ADDENDUM NO.2

WILLINGBORO PERFORMING ARTS CENTER- AUDITORIUM RENOVATION

TO: Prospective Bidders
FROM: Jim Mullan, PE
DATE: May 30, 2023
SUBJECT: **Willingboro Performing Arts Center – Auditorium Renovation
Project # WTCEX 21015**

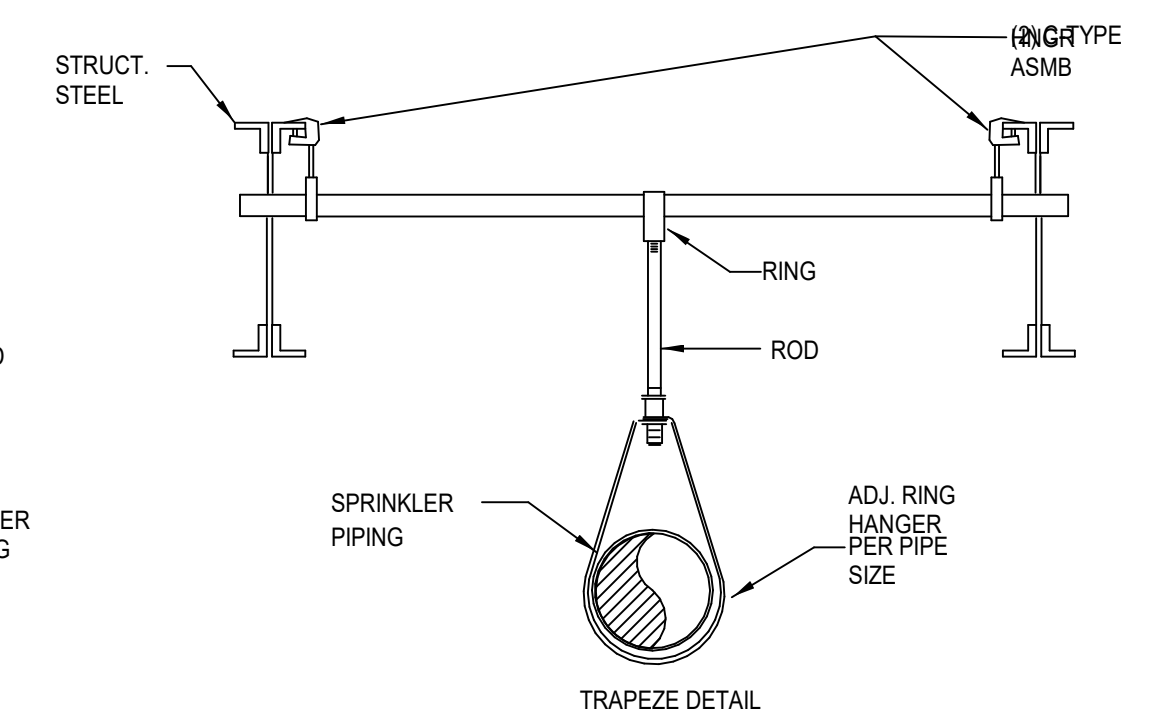
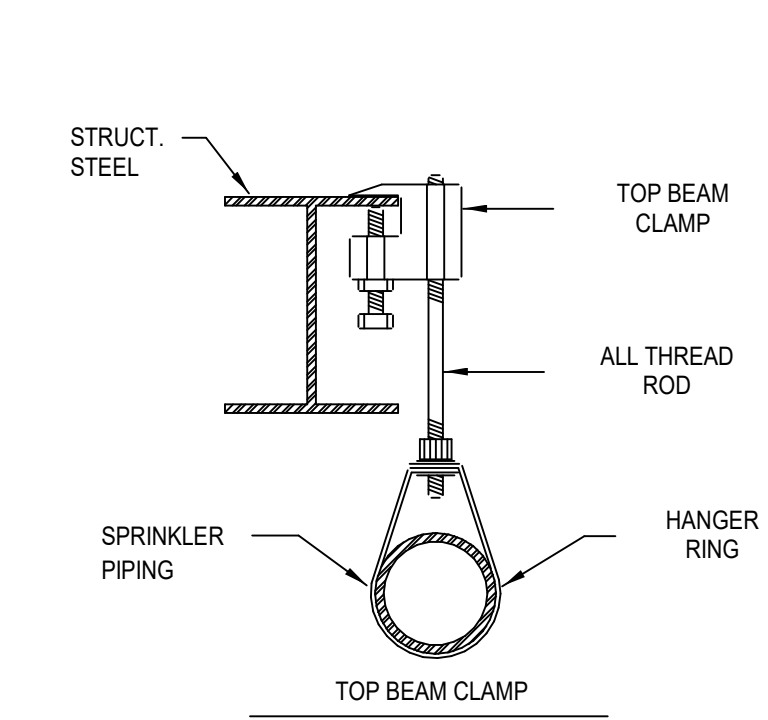
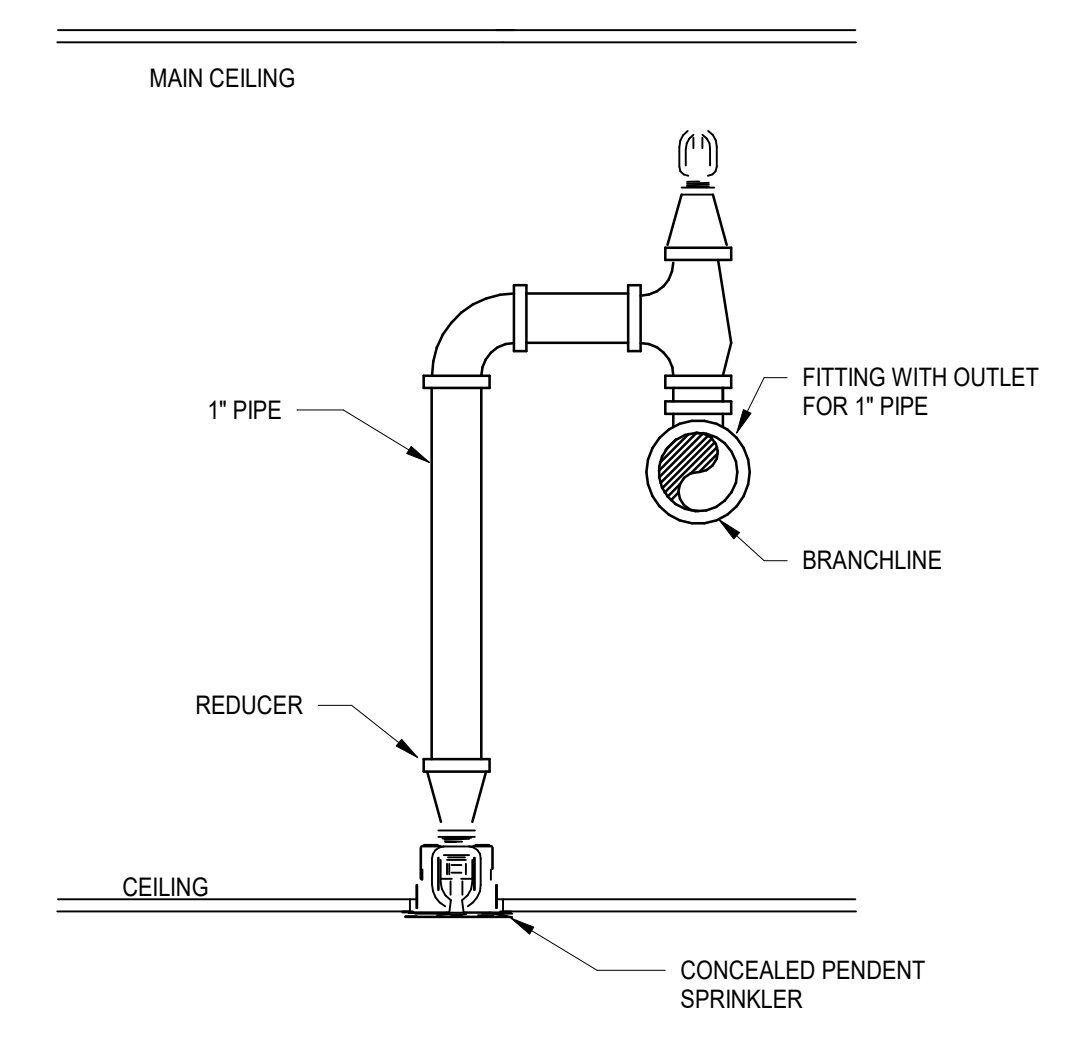
Please refer to drawing FP100. On our site visit today, it was confirmed that the ductwork above the area behind the stage (i.e. left of the stage on the drawing) is accessible only via a ladder from a storage room at the basket board courts adjacent to the stage area. The area is completely enclosed in an attic space and there are no sprinklers installed.

Please confirm that the ductwork in this area needs to have sprinklers above and beneath the ductwork per FP documents as all of them are at least 48" wide. Also, there is a portion of ductwork which has been abandoned (It looks like it was replaced by another duct located above it) If it is not removed, it will need to have sprinklers as required.

The attic space described in the question above is not part of the Contract. See Attachment B for Clarification of the Note on plan FP100. Specifically, the note applies only to the hatched area on the Plan.

SPRINKLER HEADS SHALL BE PROVIDED ABOVE AND BELOW ANY DUCTWORK 48\"/>

SPRINKLER HEADS SHALL BE PROVIDED ABOVE AND BELOW ANY DUCTWORK 48\"/>
